Version Explanation for 100443/CON-7013 BMSC

100443 – Obsolete

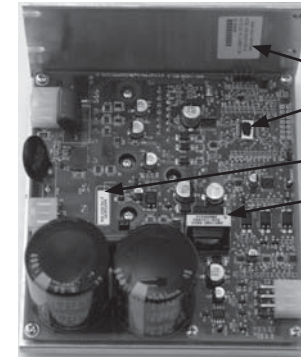
- First generation motor controller
- Known Issues: None
- If BMSC Fails:
 1. Replace with CON-7013.C
 2. Upgrade Software:
 - HhB - HHB-8144-X Rev. E or greater
 - HhB2 - HHB-8243-X Rev. C or greater
 - All other ovens: no software upgrade required

CON-7013 Rev. A – Obsolete

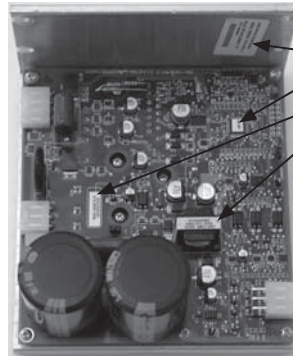
- Second generation motor controller
- Known Issues:
 - “F1” faults occur at startup and while cooking at 100%
- If BMSC Fails:
 1. Replace with CON-7013.C
 2. Upgrade Software:
 - HhB - HHB-8144-X Rev. E or greater
 - HhB2 - HHB-8243-X Rev. C or greater
 - All other ovens: no software upgrade required

CON-7013 Rev. C – Active

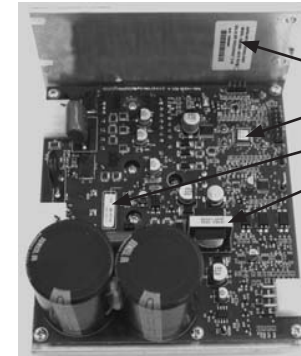
- Second generation motor controller
- Known Issues: None

How to Identify
Supplier Revision: C
Software Version: 1.50
PCB Revision: J
Transformer: Type B (vendor 1: “XFMR5”) (vendor 2: “OBP/SMC”)

CON-7013 Rev. B v1– Obsolete

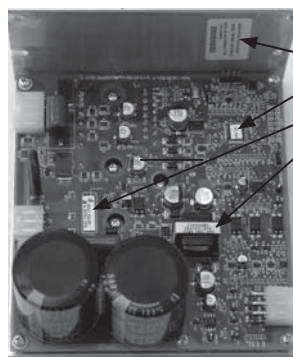
- Second generation motor controller
- Known Issues:
 - Better performance, but same issues as CON-7013 Rev. A
- If BMSC Fails:
 1. Replace with CON-7013.C
 2. Upgrade Software:
 - HhB - HHB-8144-X Rev. E or greater
 - HhB2 - HHB-8243-X Rev. C or greater
 - All other ovens: no software upgrade required
